West Wrating Parish Council's feedback to Kingsway Solar Ltd. on Targeted Consultation, January 2026

Figure 1. Change 2 proposes adding panels to fields marked B1 and B2

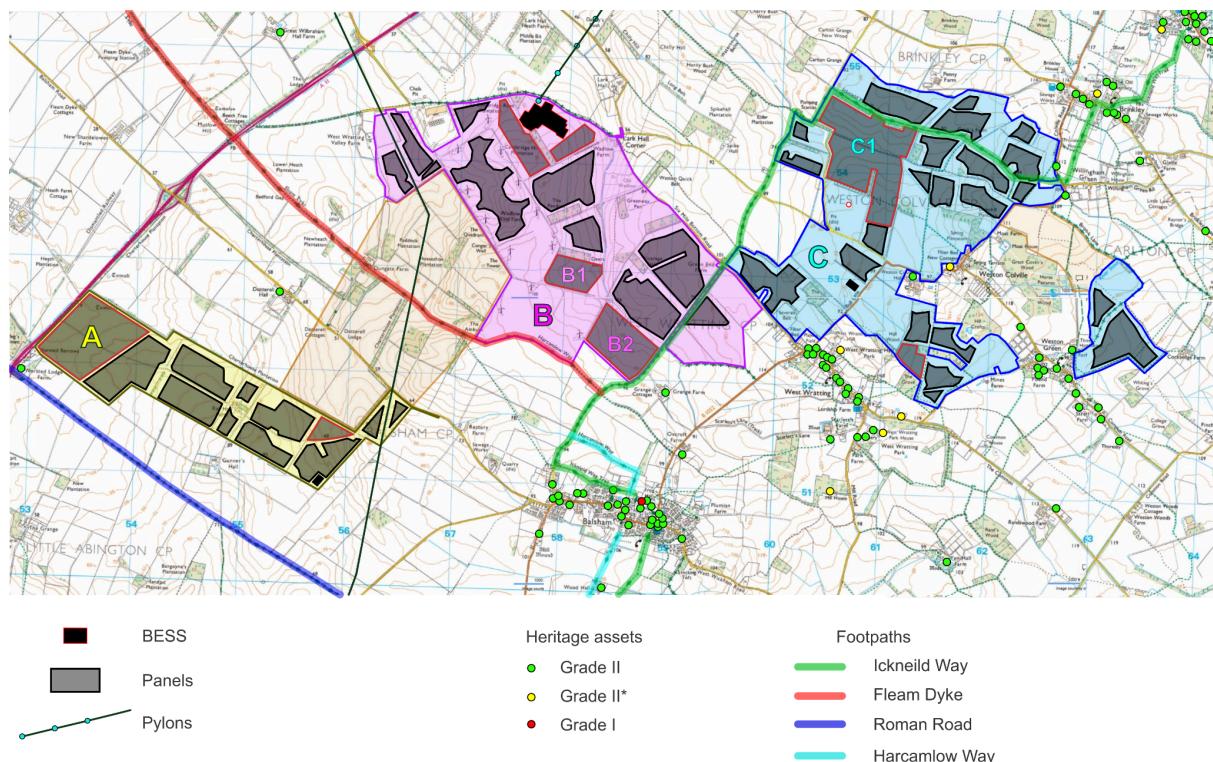
The proposed change 2 exacerbates the problem that West Wrating Parish Council highlighted as issue 2.1.1 in its statutory consultation feedback, namely the effect on landscape character and visual amenity of panels that can be seen from the historic Ickneild Way footpath.

The two fields of panels that are proposed to be added to Area B are justified in the targeted consultation documents by saying they have "limited constraints". Not only does this contradict Kingsway's previous assessment of this area (see below), but it disingenuously downplays the visual impact, which will be striking because the land is on a slope that rises up from the Ickneild Way which immediately borders the southern edge of field B2. The lie of this land means that the adverse visual effect from the added panels cannot be mitigated by planting and will be visible for miles, including from the nearby Fleam Dyke and Harcamlow Way footpaths.

Adding panels to fields B1 and B2 will also have a significant ecological impact; they are open areas that are enjoyed by skylark, lapwing, golden plover and brown hare in particular, all of which will be adversely affected, particularly by the larger block of solar panels formed by adding B2 to the two panelled areas just to the north east. Badgers are also often seen around the Ickneild Way near B2.

The proposed changes in area B again contradicts Kingsway's previous assessment of the area. On Kingsway's interactive map the area is still labelled: "No infrastructure is proposed in these locations due to the land being on a ridgeline and visible from local properties, to reduce the potential effects on PRoW in the area, and to avoid grade 2 agricultural land that has been identified through surveys. There is the potential to use part of this area for environmental mitigation". Again, It is very disappointing not to see any explanation about how the developer will compensate for the reduction in land available for environmental mitigation.
